New Deer 2 Substation and Blackhillock – New Deer – Peterhead 400kV Consultation

I am writing to express concern with the method and resulting output of your consultations on the locations for the New Deer Substation (node 4) and the associated 400 kV Overhead line, Sections 10 and 11 of the Blackhillock to Peterhead 400 kV overhead lines.

Figure 2: Impact on New Deer

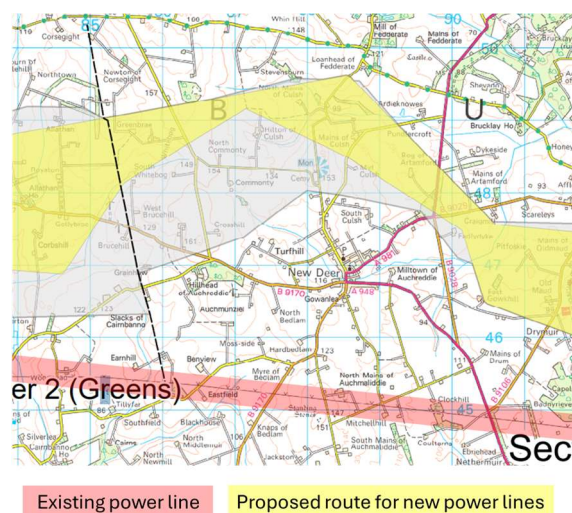
In New Deer the proposals mean that the village will become almost entirely surrounded by pylons. The widening of the route for Section 10 does nothing to mitigate this reality.

Figure 3: Alternative locations for the New Deer substation south of the existing substation.

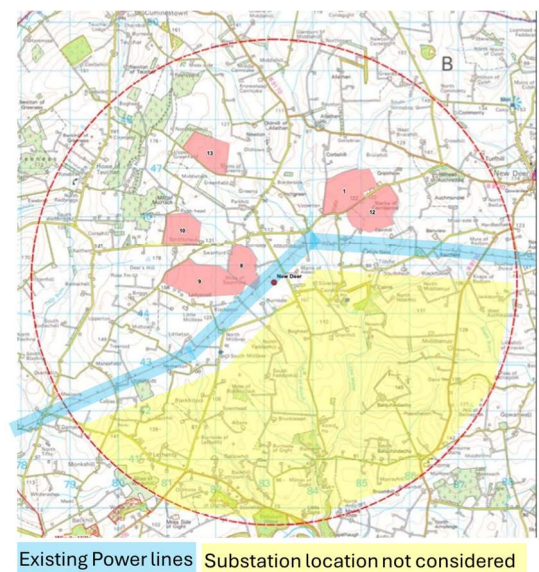
At the Huntly consultation in February 2024, it was relayed to me that sites south of the existing New Deer substation were reviewed but not included in the public consultation. This is most disappointing. Indeed, the original route options 11B, 11C1, 11C2, 11C3 and 11C4 all take a southerly route, indicating that locations in the south were considered.

A southerly location for the substation would allow for the overhead lines to run in the large area of countryside south of the existing powerlines, preventing the need for them to be routed close to the Central Buchan villages and Turriff.

True, it would make connection to (potential) generation sites in the north slightly more expensive (due to the need to cross the existing power lines), but this needs to be balanced against the reduced impact on north east residents.

The omission of these options from the consultation leads to the image that cost has been prioritised over community and that convenience has been prioritised over consultation.

Figure 5: Alternative northern route (illustrative only) for the Overhead lines (black) with the new New Deer Substation (yellow box) located more than 5km from the existing substation, connected to the existing substation with an overhead or underground line (green)

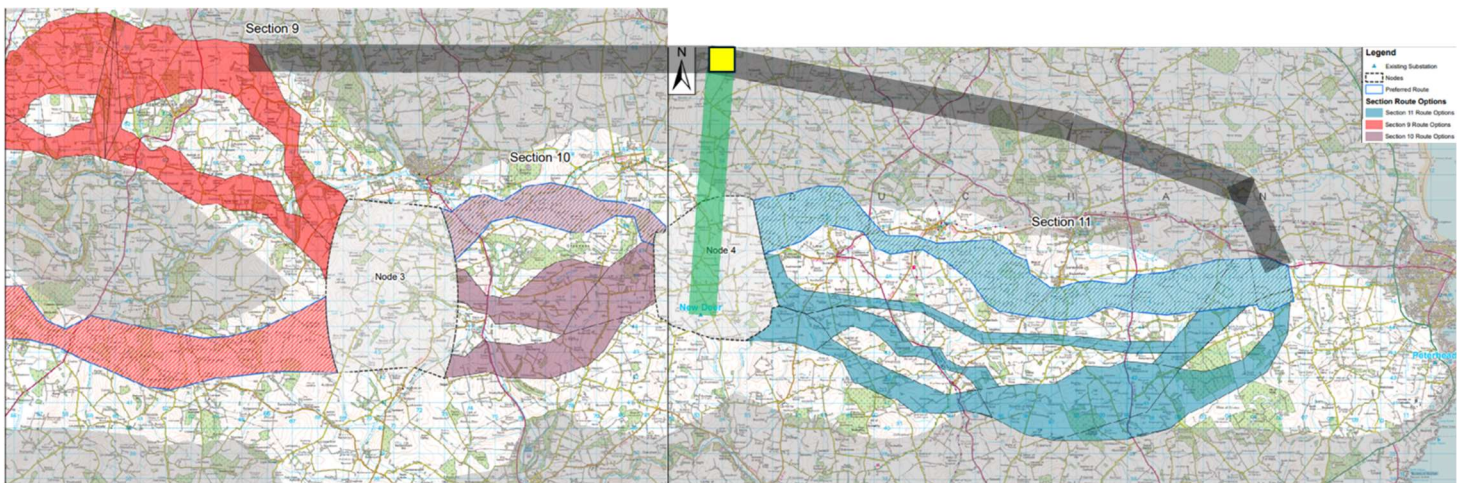
The decision to remain within 5km of the existing substations has ultimately let to the new power lines being proposed along a similar route to the old lines.

The reason quoted for keeping the new substation within 5 km of existing ones is to minimise the length of connections required. However, where the specified intent of the substation is to allow for connection of generation capacity from offshore wind, it is clear that overhead cables will be required to run into the New Deer substation from the north.

Were the existing and new substations separated by a larger distance (by overhead lines), the new Overhead Lines section 10 and 11 could run further north, both getting them closer to the generation sites and preventing the need for them to run through the busiest part of Central Buchan.

- b. An alternative design for Section 10, Section 11 and Node 4, where the New Deer substation is south of the existing overhead lines.
 - c. An alternative design for Section 10, Section 11 and Node 4, where the New Deer substation is located greater than 5km north of the existing substation.

Figure 6: Substation sites in Scotland showing that the distance between Blackhill and Peterhead is similar to that between Peterhead and Fiddes and between Fiddes and Tealing.

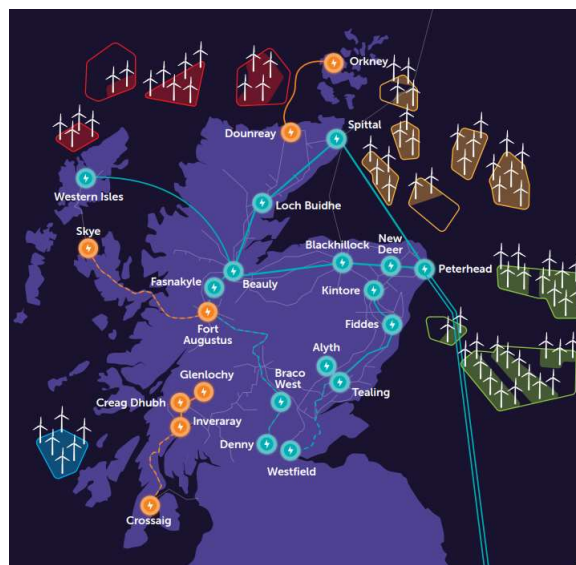
Although connecting the new Overhead Powerline to all the existing Substations makes, on paper, a better technical solution, is it actually needed?

It is clear from your Pathway to 2023 graphics that the distance between Peterhead and New Deer and Blackhillock and New Deer are far shorter than the distances between most substations along Scotland's coast.

If the requirement for a substation in New Deer was removed, the distance between Peterhead and Blackhillock would be similar to Peterhead to Fiddes and Fiddes to Tealing. If these distances are acceptable in other areas, why not between Peterhead and Blackhillock? Removing the requirement for a substation at New Deer would allow far greater freedom in selection of the overhead line route away from the Central Buchan villages and Turriff.

2. Please provide details on the engineering justification / need for a substation in New Deer, given the close proximity to Blackhillock and Peterhead Substations.
